MODIFICATION REQUEST:

***Lot 1 DP 702144 & Lot 100 DP 624581
86-96 and 100 Mount Street, North Sydney***

***MP08_0241 MOD 1 – Modification to an
Approved Commercial and Retail
Development***

Director-General's
Environmental Assessment Report
Section 75W of the
Environmental Planning and Assessment Act 1979

Figure 7 – Site Diagram of the proposed development at the Ground Floor Lobby Level demonstrating paths of travel for through-site link. The café / restaurant retail area is located on the eastern side of the building.

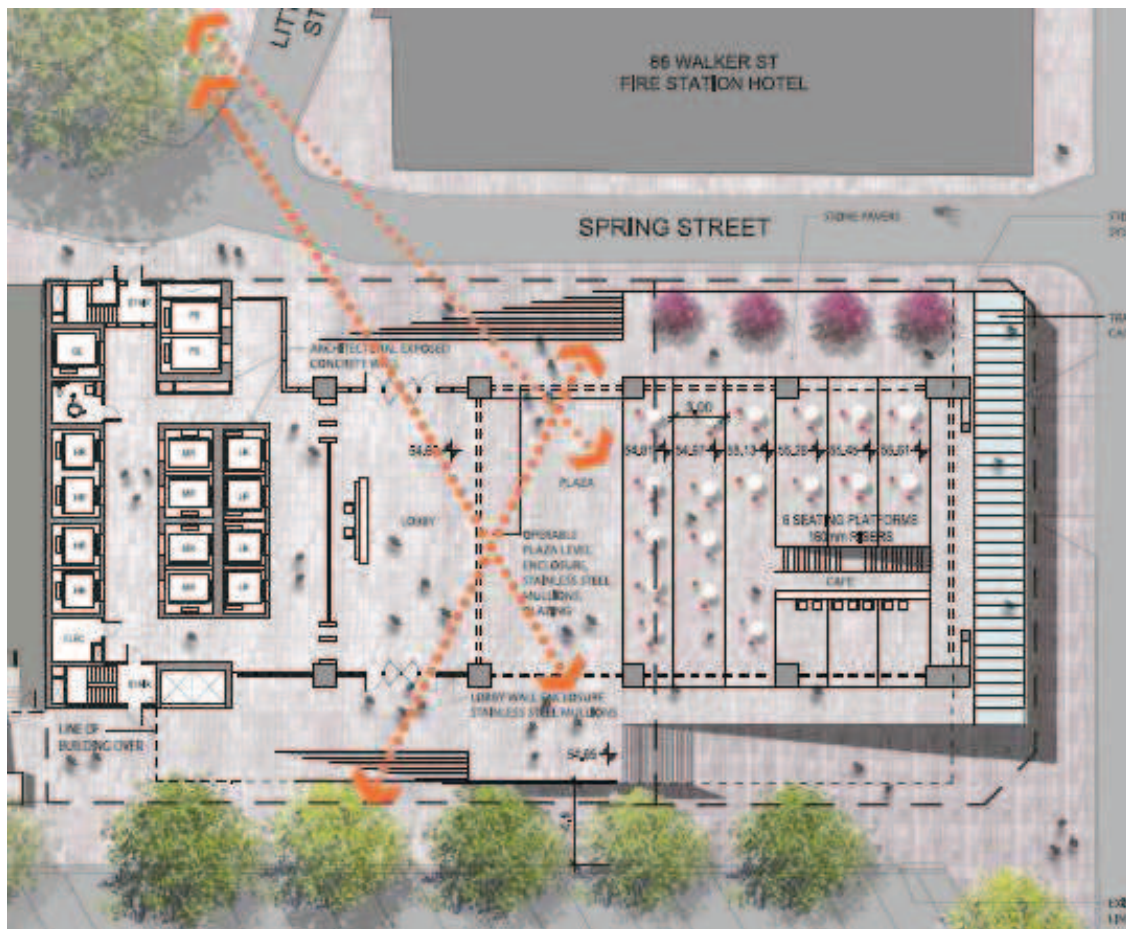
- an open plan lobby area which serves as a through-site pedestrian link during the hours of operation of the building;
- a café / restaurant retail shop on the lower ground level on the eastern side of the building with an outdoor seating area;
- a café / restaurant on the ground (lobby) floor on the eastern side of the building with openable walls;
- the removal of a street tree in Walker Street;
- relocation of the core lift services to the western side of the building;
- the relocation of the vehicular access points from Spring Street to Walker Street; and
- an awning in the Mount Street elevation to provide covered pedestrian access.

North Sydney Council requested that a condition of approval be provided requiring the street setbacks and through-site link is publicly accessible to pedestrians during the hours of operation of the building. The proponent has agreed to this condition which is provided in the recommended Instrument of Approval in Appendix C.

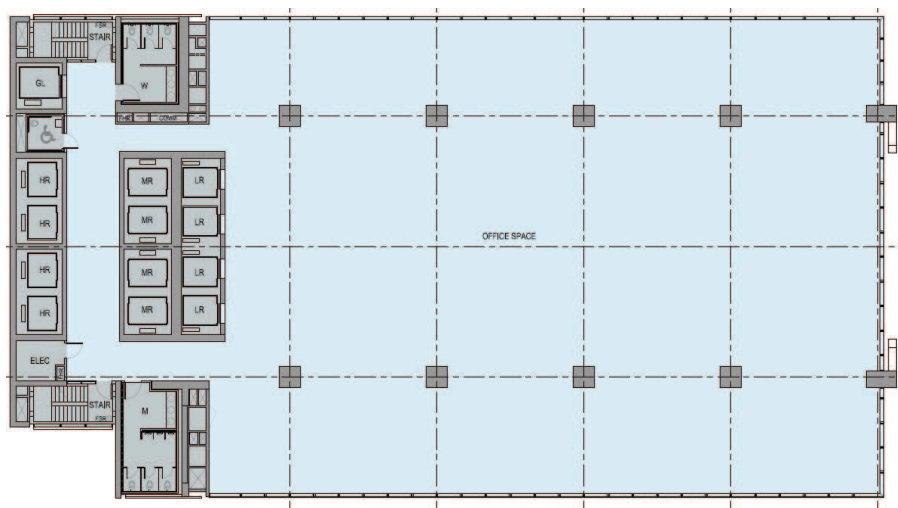
- retention of the general building envelope however with an extension of the floor layout to include the previously cut out portions of the southern side of the building (**Figures 9, 10 and 11**);
- amendment to the building setback fronting Walker Street to be 4.2 metres for all levels of the building (as per Condition B1 'Design Modifications'); and
- redesign of the architectural elements on the Walker Street façade (**Figure 5**) and an amended external schedule of materials.

- amendments to the eastern (Walker Street) setback to be 4.2 metres to comply with Condition B1;
- extension of the floor layout to include the previously cut out portions of the southern side of the building;
- relocation of the core lift services;
- removal of dedicated levels for building plant and the provision of building plant on each level;
- a reduction in the retail space; and
- an increase to the cyclist/change room facilities.

Figure 10 – Approved southern elevation of the building demonstrating the building envelope of the top of the building.

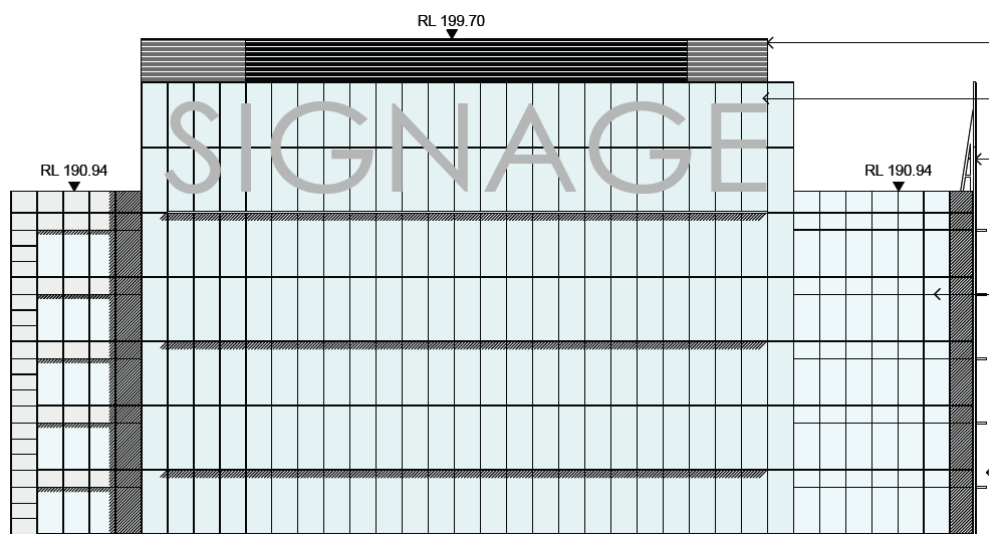
The modifications to the built form retain the maximum building height of 145.7 metres and generally retain the approved building envelope. As demonstrated in **Figures 4 and 5**, the proposed building has external architectural features which are considered to provide a more streamlined appearance and generally improve the appearance of the building. The proposed design is supported by North Sydney Council's Excellence Design Panel.

The views from nearby residences and the public domain are not considered to be adversely affected given the proposed amendments generally retain the approved building envelope and improve the appearance of the building (**Figures 3, 4, 10 and 11**).

Figure 12 – Comparative Analysis of the overshadowing of the approved development (blue) and the proposed development (red).

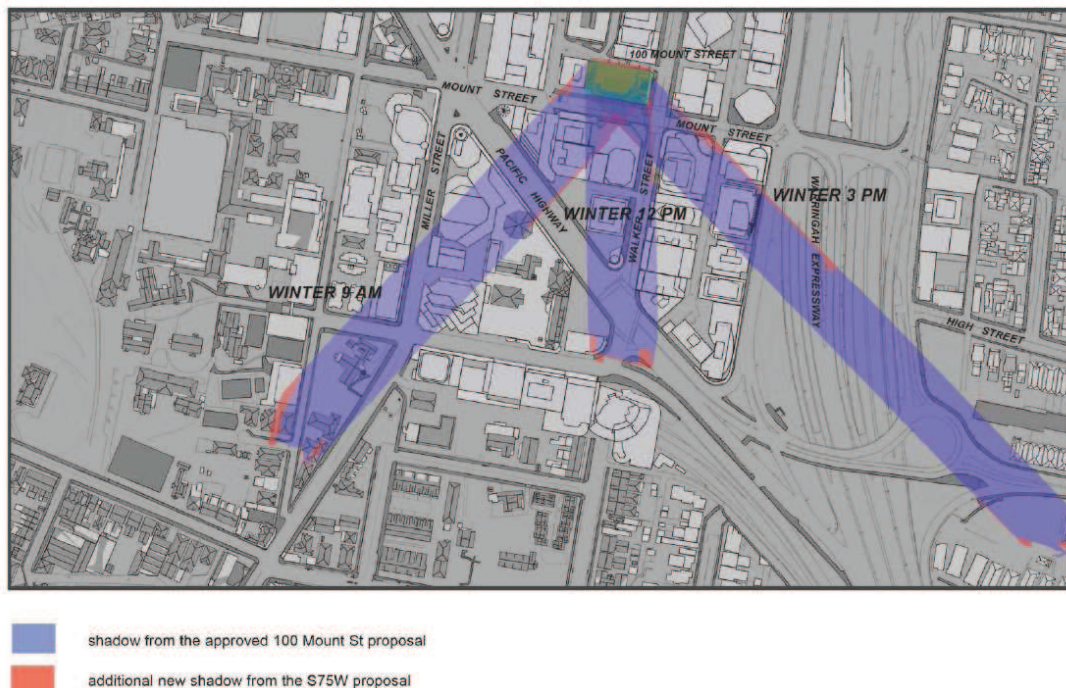
The proposed amendments to the built form result in a marginal increase to the overshadowing generated by the approved building. As demonstrated in **Figure 12** below, the proposed amendments create additional overshadowing which will affect a small portion of residential land for the 5 minutes before 3.00pm during the winter equinox, and the Mount Street Plaza between 9.00am and 11.00am, as advised in the Solar Impact Report submitted by the proponent. North Sydney Council supports the amended built form considering the additional overshadowing is minor and the amenity of nearby residential and open space areas is not adversely affected. This increase is considered to be acceptable as it represents a relatively minor increase over that already approved and will have little impact on the amenity of the surrounding land.

Figure 13 – Site Survey Plan indicating the 4 trees approved to be removed in Concept Plan MP08_0241 and the street tree in Walker Street which is proposed to be removed to accommodate the proposed vehicular access point.

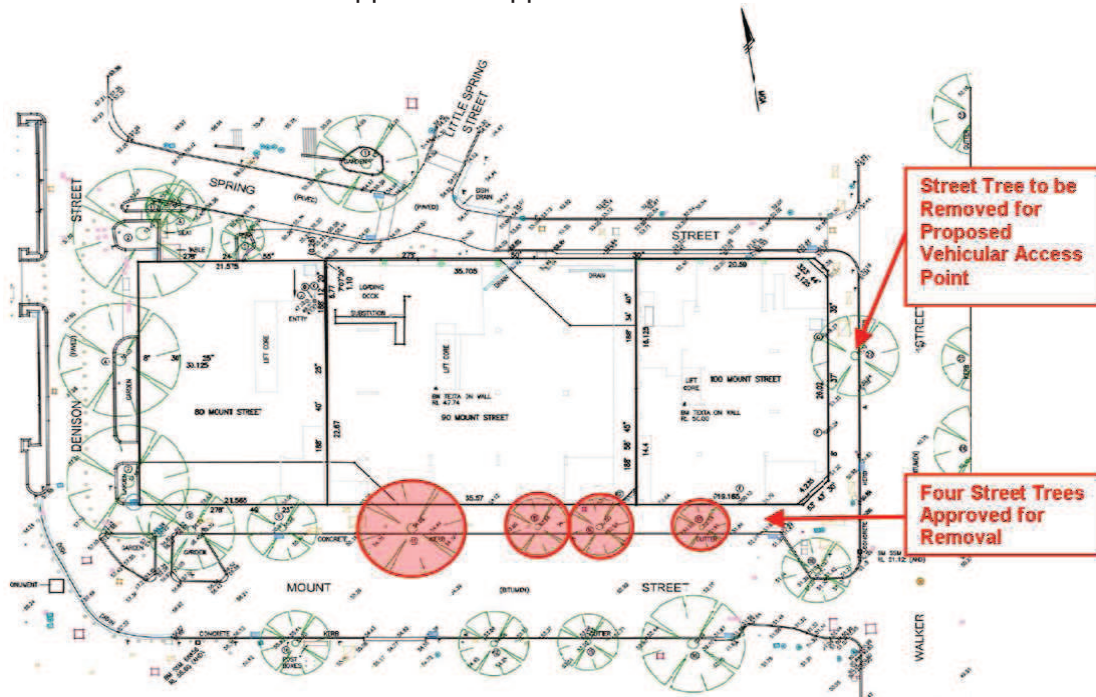
North Sydney Council's Design Excellence Panel raised concern with regard to existing street trees to be removed on Mount Street. The department notes that the Project Approval (MP08_0241) approved the removal of four of the trees located on the Mount Street footpath as demonstrated in **Figure 13** below. Condition E23 'Required Tree Planting' requires the replacement of these trees as shown in **Figure 14**. The removal of the street trees on Mount Street were assessed within the original application and the subject modification application does not seek to alter the outcome of the original assessment.

The current proposal seeks the removal of a street tree on the Walker Street footpath to accommodate the proposed vehicular access point as demonstrated in the site plan below (**Figure**

14). The Department notes that Condition B10 'Security Bond Schedule' is required to be amended to permit the removal of this tree. Council does not object to the removal of this tree and three replacement trees are also required nearby along the Walker Street frontage. Noting these points and the fact that the site is within an established CBD environment, the department considers the removal of this tree and subsequent amendment to Condition B10 to be appropriate as detailed in the recommended Instrument of Approval in Appendix C.
